## Independent Technical Review of the Focused Feasibility Study and Proposed Plan for Designated Solid Waste Management Units Contributing to the Southwest Groundwater Plume at the Paducah Gaseous Diffusion Plant

May 2011

**Prepared by:** The DOE EM Center for Sustainable Groundwater and Soil Solutions, Savannah River National Laboratory, Aiken SC

Figure 5. Interpreted lithostratigraphy for the Oil Landfarm (SWMU 1) from the SW Plume Area FFS

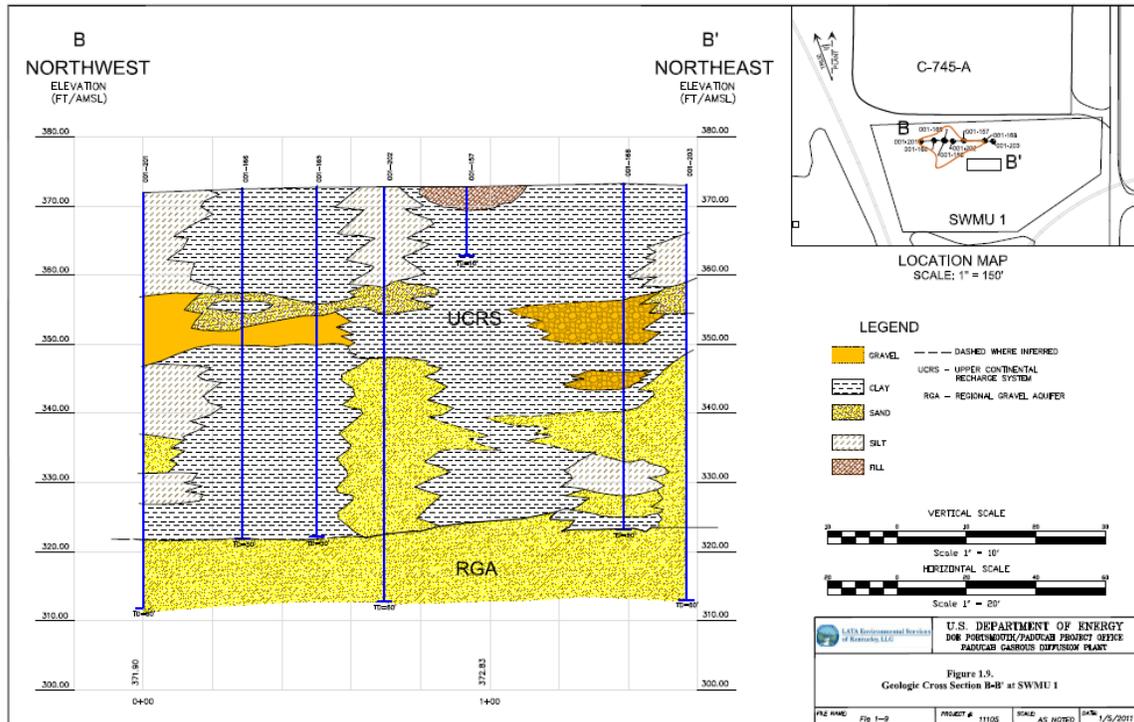
The ITR suggests that the site-specific lithologic structure, a heterogeneous fine-grained zone overlying a coarse-grained aquifer, is a key (and controlling) feature of this site. Further, the ITR suggests that the location, geometry, and character of sand lenses in the UCRS and the location, geometry, and character of the UCRS/RGA interface are features that assist in optimizing and focusing treatment.

Figure 6. Interpreted contaminant cross section for the Oil Landfarm (SWMU 1) from the SW Plume Area FFS

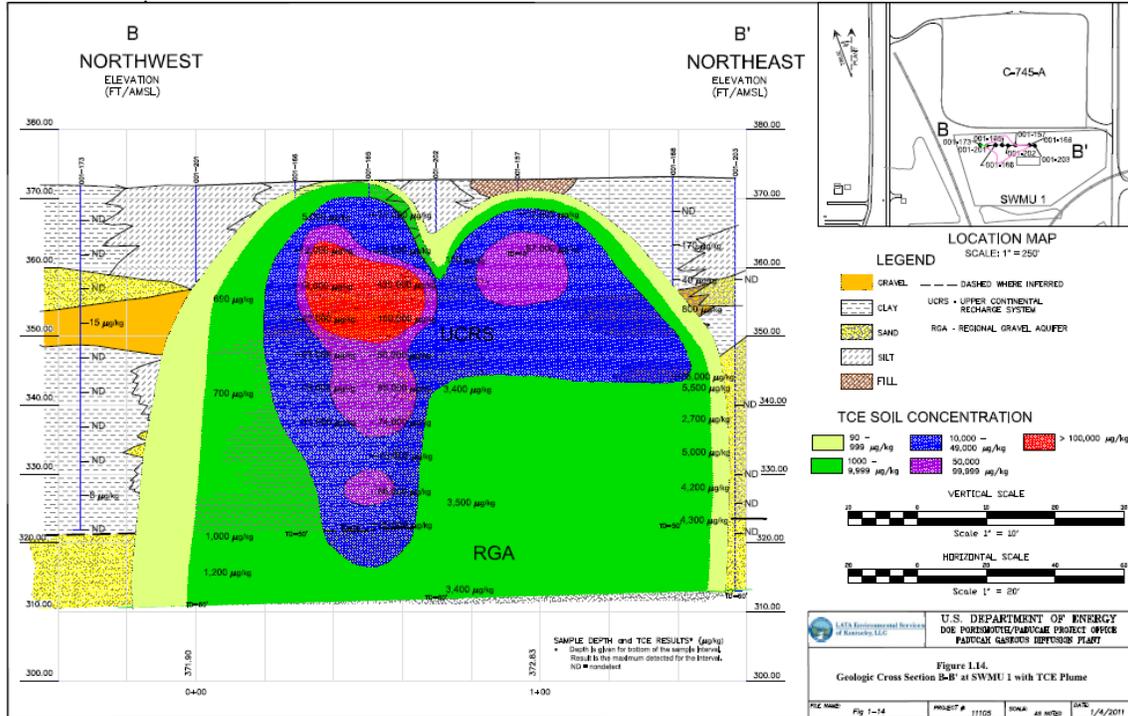
The opportunity to beneficially utilize this subsurface structure and contaminant geometry is somewhat reduced by the FFS interpreted contaminant distribution that was projected from the soil/sediment characterization data (Figure 6). Note that the contaminants are contoured somewhat isotropically (i.e., with minimal fidelity to the lithostratigraphy). An alternative presentation of the data (Figure 7) provides more insight into the contaminant distribution (location, and geologic controls). In this form, it is relatively clear that the most contaminated materials are associated with high permeability zones in the UCRS. Further, these zones are significantly above the piezometric surface of the RGA – suggesting the potential viability of SVE (following limited water removal as needed).

Figure 8. Lithostratigraphic areas of opportunity for the Oil Landfarm (SWMU 1)

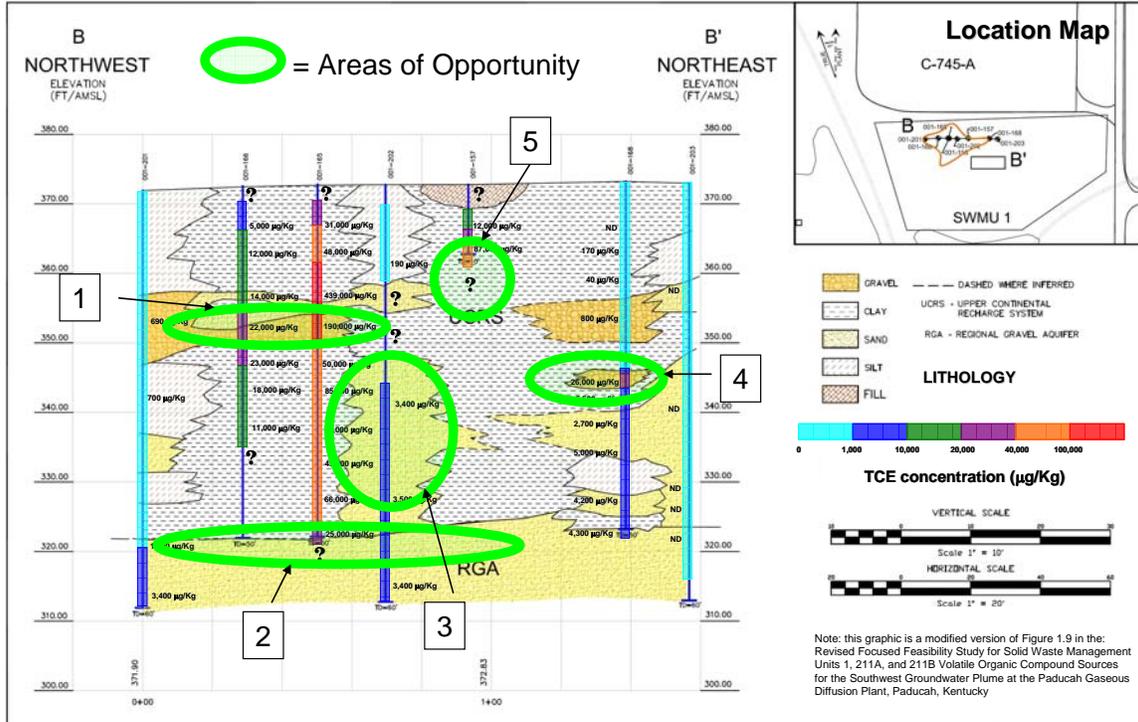
This simple concept is further developed in Figure 8. This figure overlays several areas of opportunity that can be considered for standard or innovative treatment options. Several targets have been highlighted to illustrate some, but not all, of the areas that could be selected for targeted treatments or pilot tests. Area 1 is a high permeability zone with very high concentrations of contaminants just below a low permeability zone with even higher concentrations of contaminants. This area in the vadose zone could be used in a variety of ways including: a) SVE, b) as a focused injection point receiving oxidants or reductants, c) as an area for deep soil mixing and blending of reagents, or d) as an extraction point for localized heating. Area 2 is below the water table and represents a “sharp” interface between an upper fine-grained UCRS and the more permeable RGA. This area could be used to deploy amendments that would form a barrier treatment and/or partitioning zone. An example might entail the injection of buoyant liquid carbon substrate (e.g., vegetable oil) or the sequential injections of zero valent iron (ZVI) and low-density liquid carbon. Area 3 is a high permeability vertical column bridging the saturated and unsaturated zones. This area appears to be a natural funnel that may be used as a treatment zone by: a) SVE or b) filling or partially filling with amendment. One could envision the development or injection of an amendment gas in this area that could diffuse into the lower permeability, more highly contaminated areas around it. Area 4 is a localized high permeability zone with relatively high contaminant concentrations (this zone may be connected with the other contaminated high permeability zones out of the plane of the cross section). This area could be specifically targeted for treatment similar to Area 1. Area 5 is poorly characterized but may be a target for a) oxidant candle technology (EPA, 2011, or a similar granular oxidant diffusion borehole deployment), b) multiple, closely spaced injections of amendment, or c) deep soil mixing and blending of reagents. It is important to bear in mind that this list is not comprehensive and should only be used as a starting point for examining and matching geologic/contaminant distribution occurrences (opportunities) with remediation performance and deployment characteristics.

Figure 11. Modeled TCE Mass Remaining in the UCRS at SWMU 1 during SVE Lite

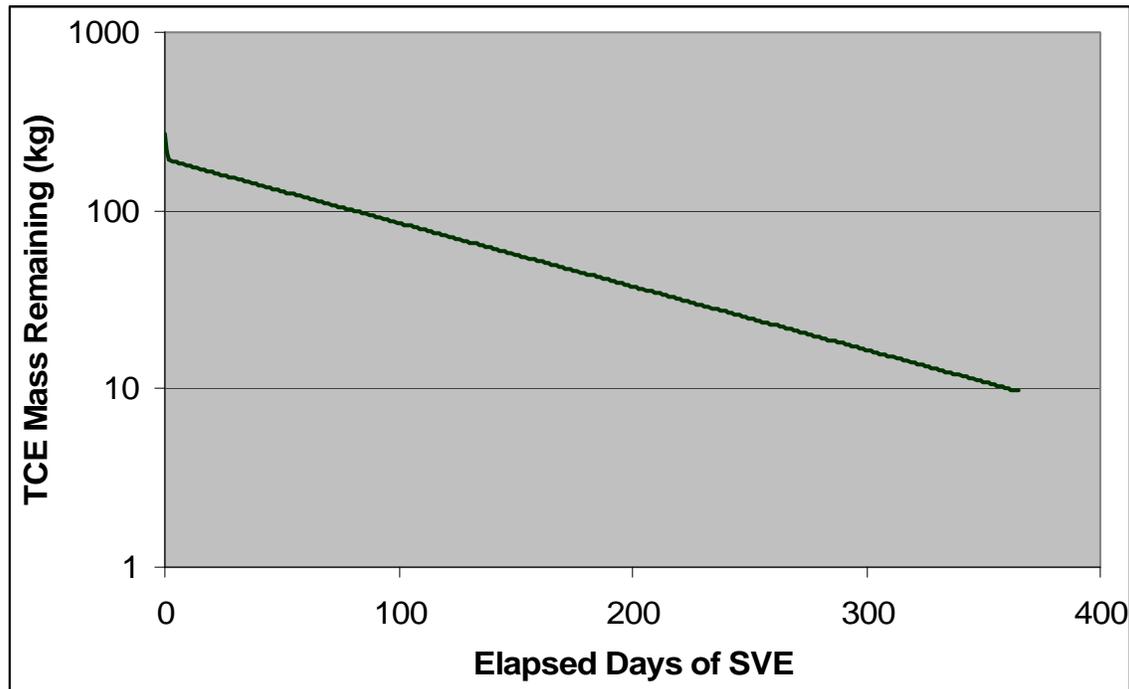
All of the assumed parameters and model results are provided in Appendix C. An example model output is provided in Figure 10. This figure projects the mass in the site using a modest SVE Lite system, assuming an extraction rate of 60 standard cubic feet per minute (scfm) that can be achieved using a 1.5-horsepower regenerative blower operating at a vacuum of 50 inches of water powered with about 1,500 watts of energy from a standard, single-phase, 20-amp circuit. Figure 10 demonstrates that the permeable zone is swept rapidly and then mass transfer constraints limit the mass extraction rate. For the rough estimates of this review, the model suggests nearly 90% of the source TCE mass in the UCRS at the Oil Landfarm (SMWU 1) could be extracted in about 7 months

of SVE at the low flow rate of 60 scfm. Monitoring of the system during startup would help reduce uncertainties and allow a more precise estimate of timeframe.

Figure 12. Simplified schematic diagram of UCRS/RGA Interface targeted remediation

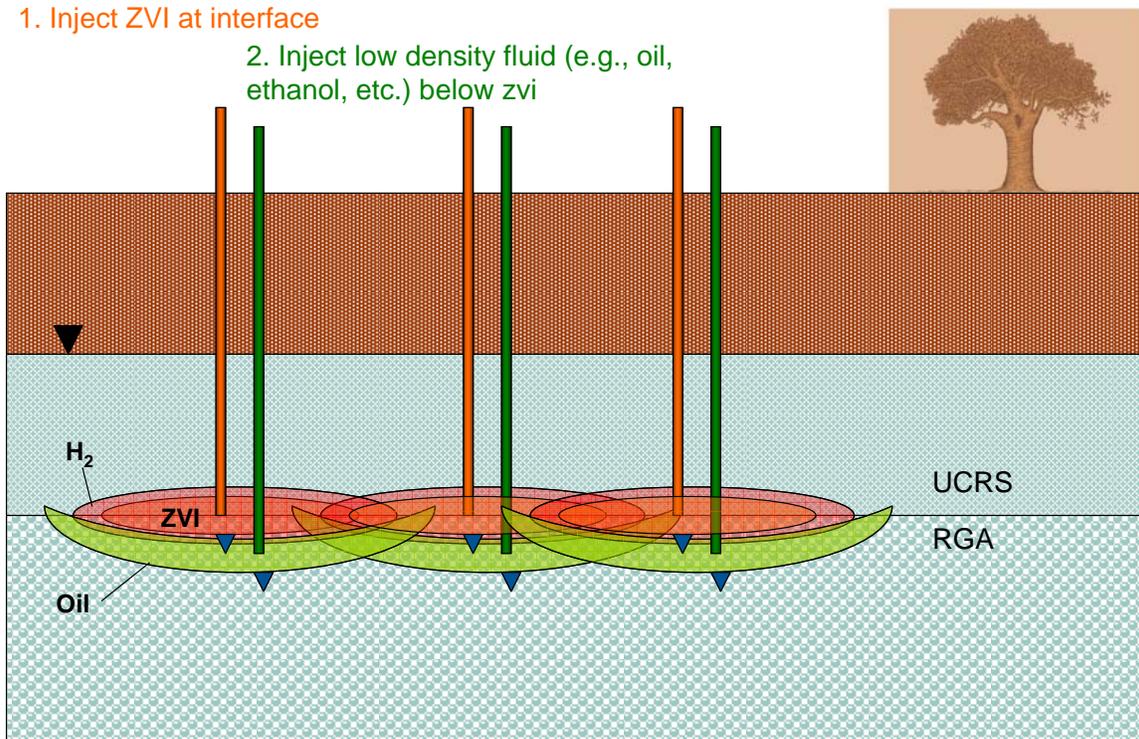
One realization of this strategy may potentially involve injections of ZVI just below the fine/coarse-grained interface followed by injections of a low density liquid (like oil or other compounds or mixtures) below the ZVI (Figure 12). The ZVI will provide a permeable reactive zone for chlorinated contaminants to be chemically reduced as they migrate down. The ZVI will also produce hydrogen gas and will enhance the production of methane gas; both of these gases will rise up and laterally along the fine grain zone interface, promoting biological reduction. Supplemental injection of a buoyant, low density liquid below the ZVI will seal the reducing zone created by the ZVI and

hydrogen and insulate the reduction zone and hydrogen from the fast flowing oxygenated water in the coarse zone. Of course, the low density liquid may also serve as carbon substrate for additional biological activity as well and a partitioning barrier. To our knowledge, this technique has not yet been intentionally implemented at a site, and will require pilot scale testing to verify performance.

Figure 1. Modeled TCE Vapor Concentrations at SWMU 1 during SVE at 60 scfm

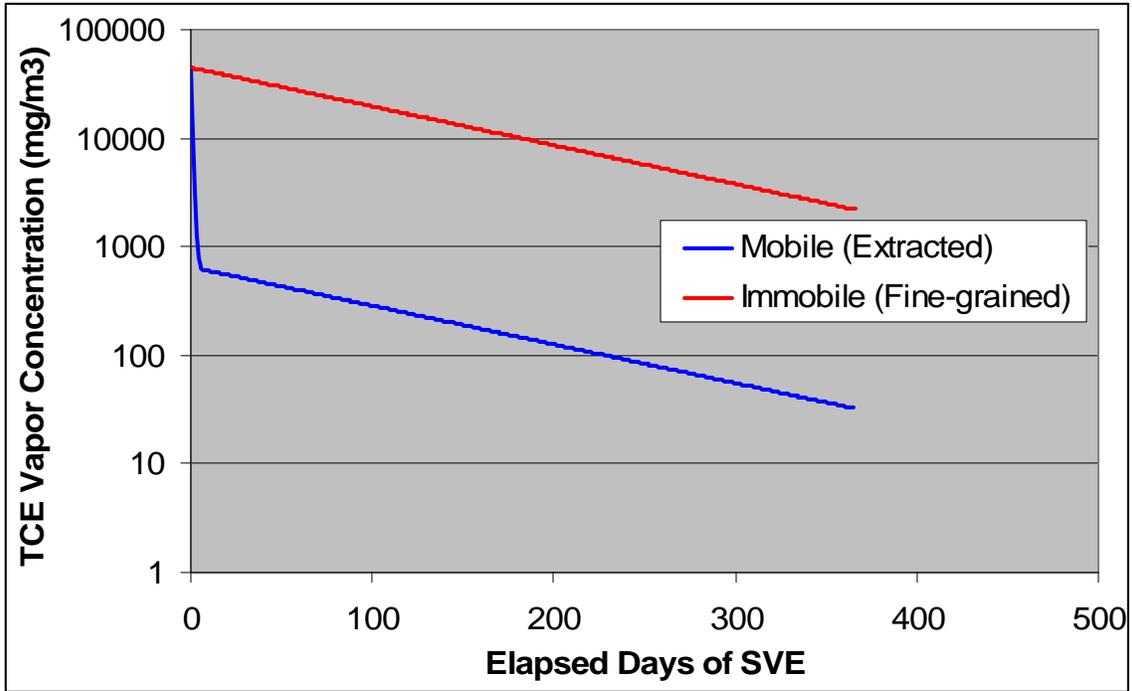
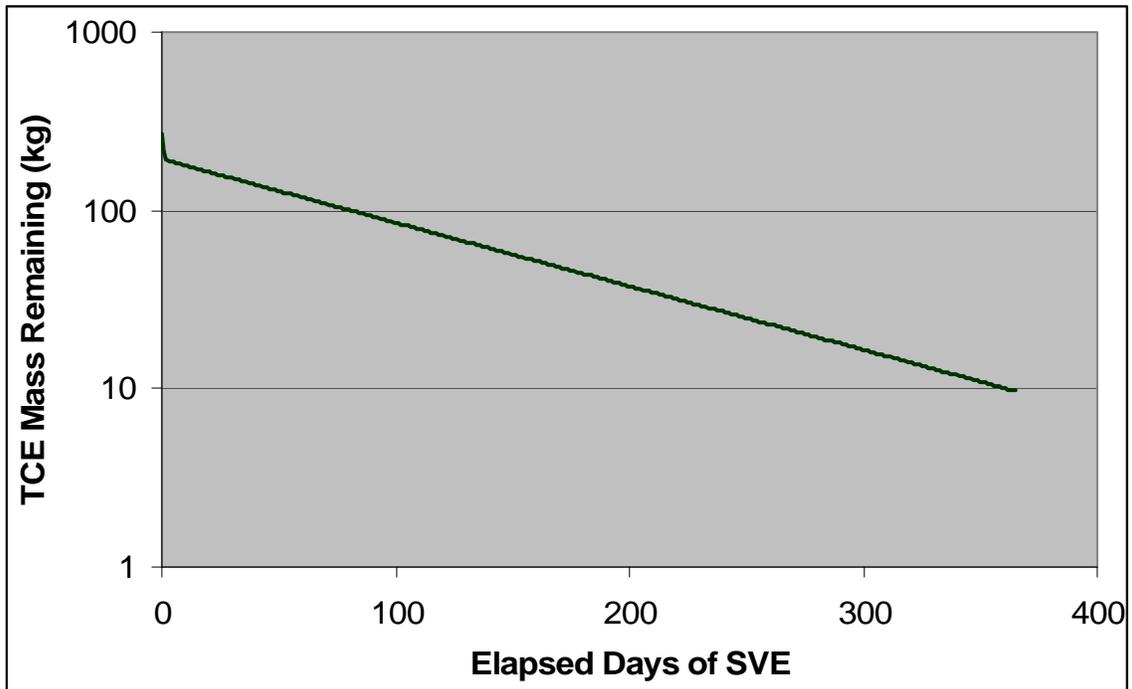
Results of the SVE modeling are illustrated in Figures 1 and 2 below. Figure 1 illustrates the vapor concentration histories in the mobile and immobile zones over time with a vapor extraction rate of 60 standard cubic feet per minute (scfm). This flow rate can be achieved with a 1.5-horsepower regenerative blower operating at a vacuum of 50 inches of water. Such a small blower utilizes about 1,500 watts of energy and can be powered with a standard, single-phase, 20-amp outlet. The mobile zone vapor concentration history shows a steep decline as this region is initially swept and then mass transfer constraints limit the mass extraction rate. The difference between the mobile and immobile zone vapor concentrations represents the driving concentration gradient for mass transfer. The estimated mass remaining at the site over time is illustrated in Figure 2. For the rough estimates of this review, the model suggests nearly 90% of the source TCE mass in the UCRS at Oil Landfarm (SMWU 1) could be extracted in about 7 months of SVE at the low flow rate of 60 scfm.

Figure 4. Modeled TCE Vapor Concentrations at Bldg C-720 during SVE at 60 scfm

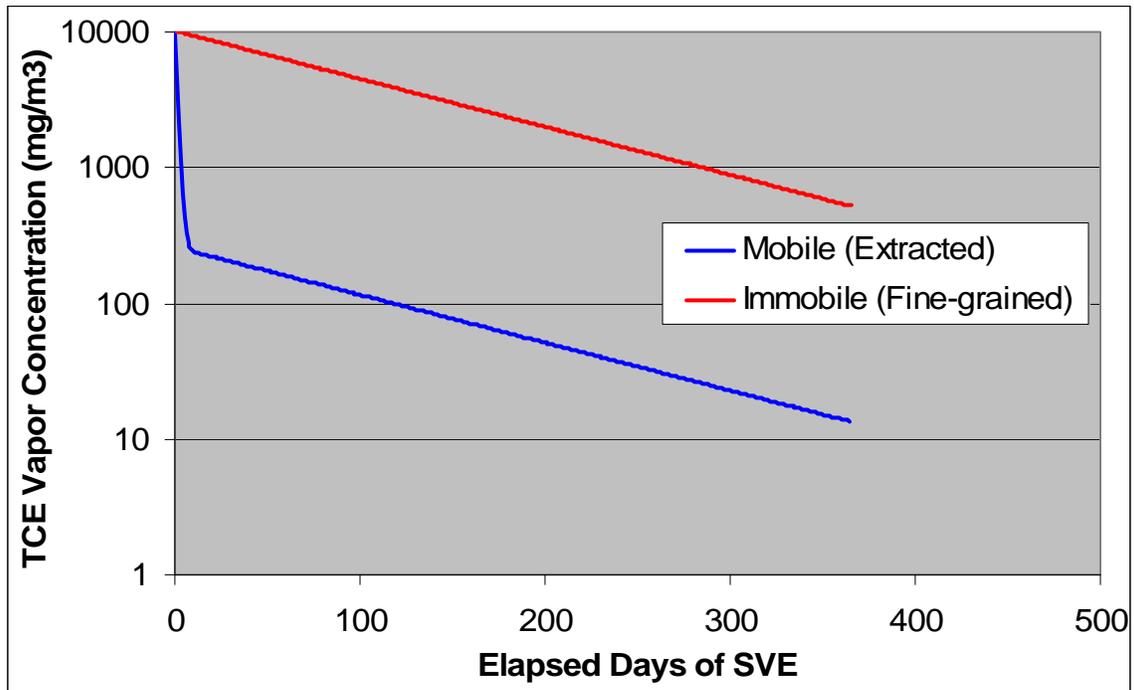
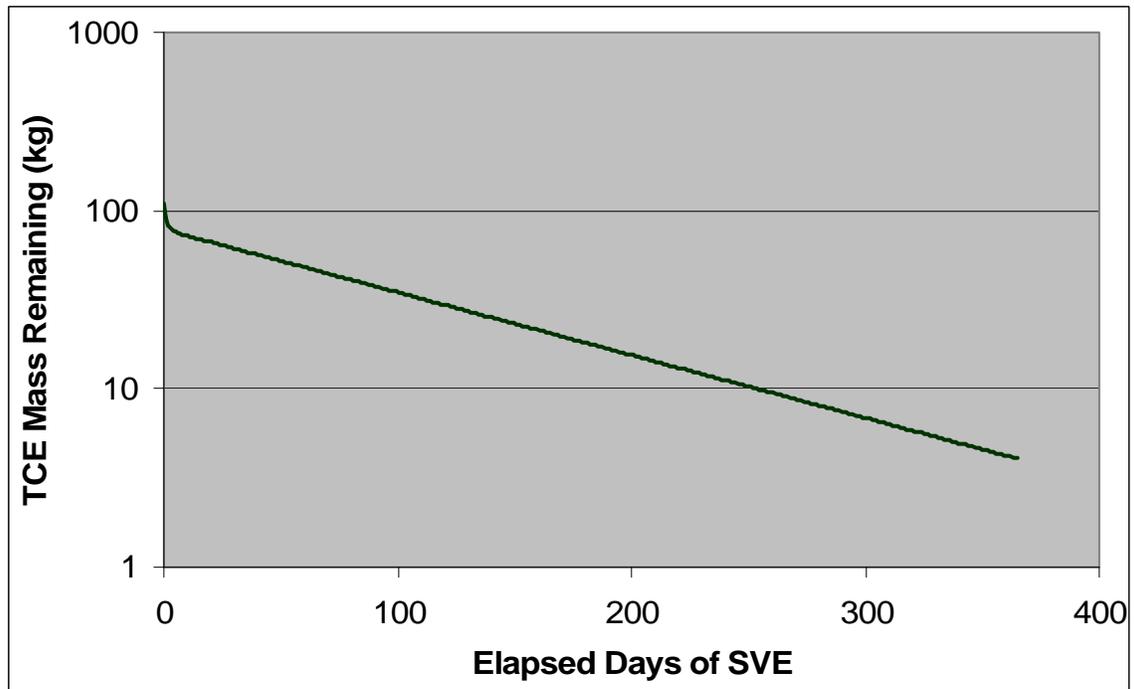
Results of the SVE modeling are illustrated in Figures 4 and 5 below. Figure 4 illustrates the vapor concentration histories in the mobile and immobile zones over time with a vapor extraction rate of 60 scfm. As described previously, this flow rate can be achieved

with a 1.5-horsepower regenerative blower operating at a vacuum of 50 inches of water. Such a small blower utilizes about 1,500 watts of energy and can be powered with a standard, single-phase, 20-amp outlet. The mobile zone vapor concentration history shows a steep decline as this region is initially swept and then mass transfer constraints limit the mass extraction rate. The difference between the mobile and immobile zone vapor concentrations represents the driving concentration gradient for mass transfer. The estimated mass remaining at the site over time is illustrated in Figure 5. For the rough estimates of this review, the model suggests nearly 90% of the source TCE mass in the UCRS at Building C-720 (SWMU 211A/211B) could be extracted in about 6 months of SVE at the low flow rate of 60 scfm.
